[Docket No. FAA-2025-0618; Project Identifier AD-2024-00637-T; Amendment 39-23280; AD 2026-05-07]

Airworthiness Directives; The Boeing Company Airplanes

Final rule.

Figure 1 to Paragraph (h)(4)—Cap Seal Minimum Thickness (All Dimensions in Inches)

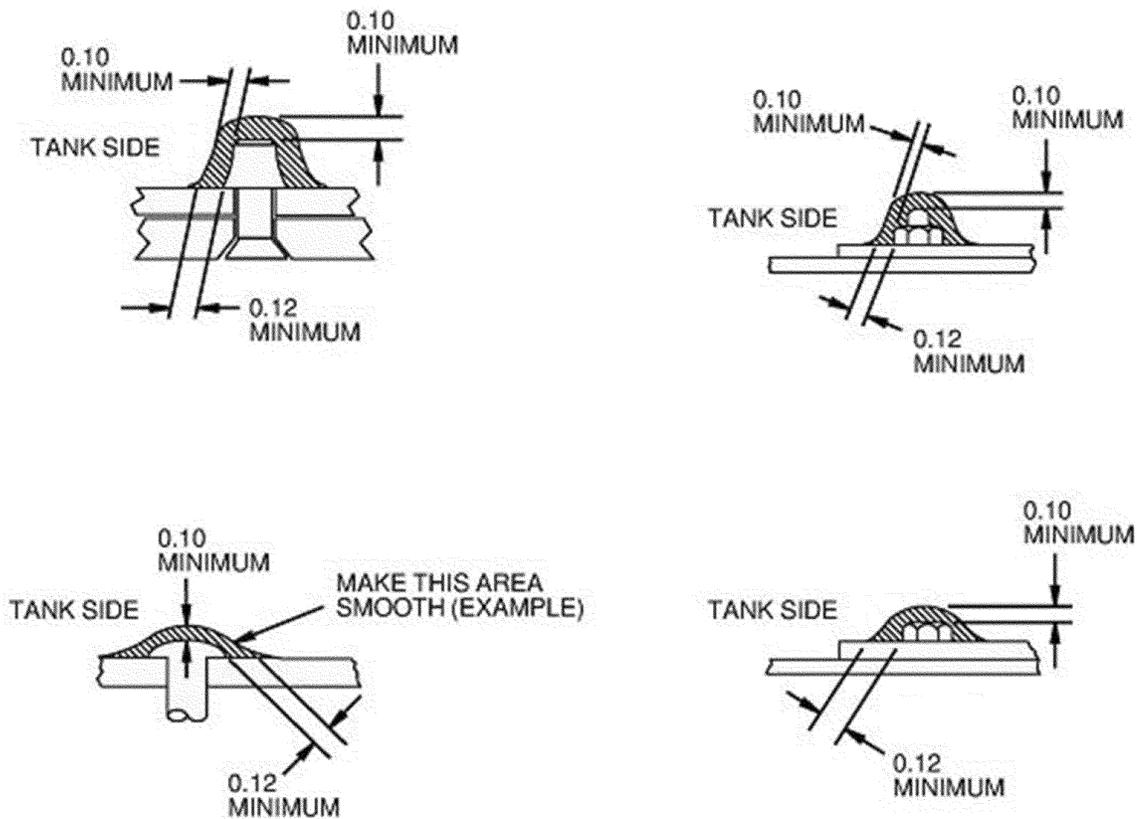
Boeing requested that the FAA remove paragraph (h)(3) and figure 1 from the proposed AD. Boeing stated Boeing Alert Requirements Bulletin 767-57A0148 RB, dated October 10, 2024, refers to section 28-11-00 of the 767 Aircraft Maintenance Manual (AMM) (*i.e.*, 767 AMM 28-11-00) for the cap sealing procedure, and the AMM contains the same cap seal minimum thickness specified in figure 1 to

paragraph (h)(3) of the proposed AD. Boeing asserted that deleting the proposed requirement would prevent duplication of data and potential questions from operators.

Alternatively, Boeing requested the FAA revise paragraph (h)(3) of the proposed AD to clarify that the requirement applies to in-tank fastener cap sealing only and add a note to refer to 767 AMM 28-11-00 as an acceptable cap sealing procedure for in-tank fasteners. Boeing stated this clarification would prevent potential questions from operators and eliminate conflicting cap sealing requirements for out-of-tank fasteners.

FedEx requested that the FAA remove figure 1 and revise paragraph (h)(3) of the proposed AD to require application of the cap seals to wing tank fasteners internally, in accordance with section 51-20-05 of the 767 Structural Repair Manual (SRM) (*i.e.*, 767 SRM 51-20-05). FedEx stated the exception in paragraph (h)(3) of the proposed AD would result in multiple requirements for cap sealing of fasteners internal to the fuel tank, depending on the task being worked. FedEx also stated that the exception is overly general and should be specific only to cap seals internal to the fuel tank. FedEx noted fasteners that penetrate the 767 fuel tank are subject to Critical Design Configuration Control Limitations (CDCCLs) to ensure the lightning, fault current, and hot short protection requirements of Airworthiness Limitation (AWL) 28-AWL-08 are met. FedEx also noted that AWL 28-AWL-08 specifies no additional FAA Oversight Office approval is required if the repair or alternation is accomplished using 767 SRM procedures.

The FAA agrees that the cap sealing requirement of paragraph (h)(4) of this AD (corresponding to paragraph (h)(3) of the proposed AD) does not apply to fasteners outside the fuel tank. Accordingly, the FAA has revised paragraph (h)(4) of this AD to clarify the requirement applies only to fasteners, fastener heads, and fastener threads and collars inside the fuel tank.

The FAA disagrees with Boeing's request to remove the exception or add a note to refer to 767 AMM 28-11-00 as an acceptable procedure for the cap sealing required for in-tank fasteners. Boeing Alert Requirements Bulletin 767-57A0148 RB, dated October 10, 2024, already refers to 767 AMM 28-11-00 as an acceptable procedure, so including such a note in this AD is unnecessary. Further, referencing material as an accepted procedure does not make the actions in the material mandatory. Therefore, the FAA has determined that the exception in paragraph (h)(4) is necessary to ensure the cap sealing procedures are enforceable.

As stated previously, the FAA agrees that the cap sealing requirement does not apply to fasteners outside the fuel tank and has revised paragraph (h)(4) of this AD accordingly. However, the FAA disagrees with the commenter's request to require that the cap sealing for in-tank fasteners be done in accordance with 767 SRM 51-20-05 because the SRM refers to 767 AMM 28-11-00 for sealing of fuel tank repairs. Referring to 767 AMM 28-11-00 does not make the actions in that material mandatory, and the FAA has determined that the requirements in paragraph (h)(4) of this AD must be accomplished. Further, the FAA disagrees that the exception will result in multiple requirements for cap sealing of fasteners internal to the fuel tank because the 767 AMM 28-11-00 contains the same procedures as the requirements of figure 1 to paragraph (h)(4) of this AD. The FAA has not changed the AD in this regard.

(4) During application of any cap seal to a fastener, fastener head, and fastener threads and collars inside the tank, as required by this AD, the cap seal must be applied with a thickness equal to or greater than the dimensions specified in figure 1 to paragraph (h)(4) of this AD.
